PCN# 20130628003
Assembly/Test Offload for the LM3401MM* Product Family at AP1 and ASESH
Change Notification / Sample Request

PCN Number:	20130628003			PCN Date:	07/02/2013
Title:	Assembly/Test Offload for the LM3401MM* Product Family at AP1 and ASESH				
Customer Contact:	PCN Manager	Phone:	+1(214)480-6037	Dept:	Quality Services
Proposed 1st Ship Date:	10/02/2013	Estimated Sample Availability:			07/03/2013
Change Type:					
<input checked="" type="checkbox"/> Assembly Site	<input type="checkbox"/>	Assembly Process	<input checked="" type="checkbox"/>	Assembly Materials	
<input type="checkbox"/> Design	<input type="checkbox"/>	Electrical Specification	<input type="checkbox"/>	Mechanical Specification	
<input checked="" type="checkbox"/> Test Site	<input type="checkbox"/>	Packing/Shipping/Labeling	<input type="checkbox"/>	Test Process

Sample Product Shipping Label (not actual product label)

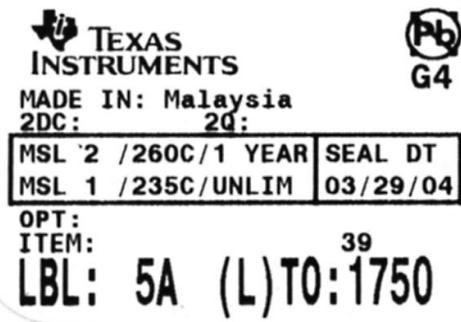
Changes to product identification resulting from this PCN:

Assembly Site

Carsem (CRS)	Assembly Site Origin (22L)	ASO: CRS
Amkor/Philippines (AP1)	Assembly Site Origin (22L)	ASO: AKR
ASE/Shanghai (ASESH)	Assembly Site Origin (22L)	ASO: ASH
